# THE STANDARD AT SEATTLE - THE TOWERS

## RECOMMENDATION MEETING

DPD PROJECT #: 3033094

RECOMMENDATION MEETING: MARCH 23, 2020

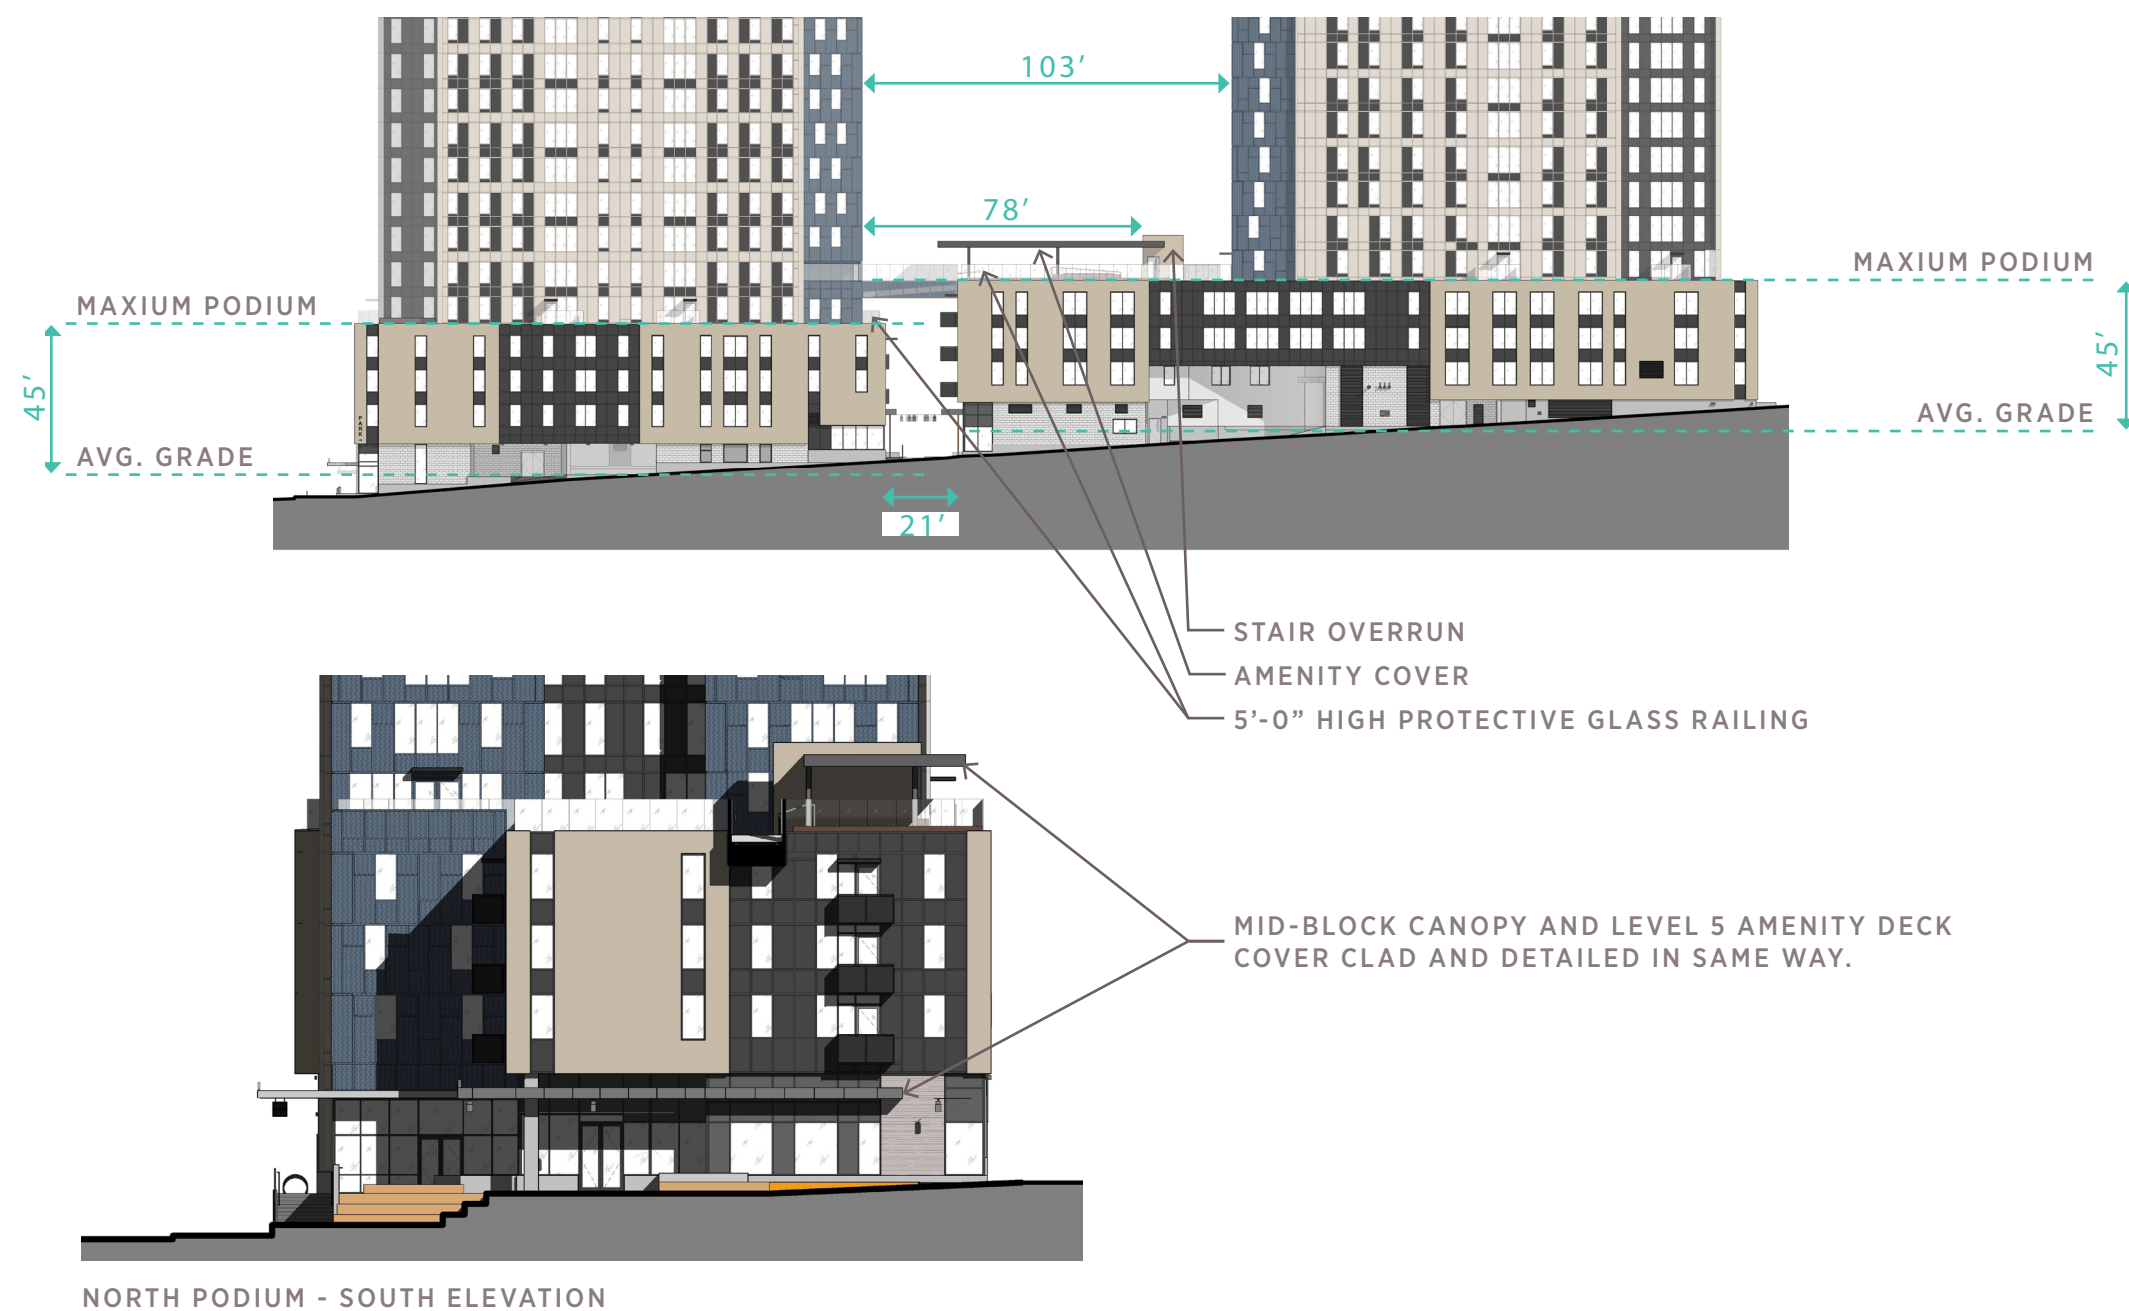
The Board indicated the possibility of supporting this departure provided the successful resolution of the issues around the jewel element previously identified. (DC2, DC2-C-2, DC2-6 Dual Purpose Elements)

The level 5 amenity deck cover, glass railing, and stair overrun have been developed to tie into the overall look and feel of the podium levels, as well as tie back down to the ground level detailing. These become an extension and termination to the exposed jewel space. These elements become the legible roof lines for the jewel space and help provide a focal point within the project.
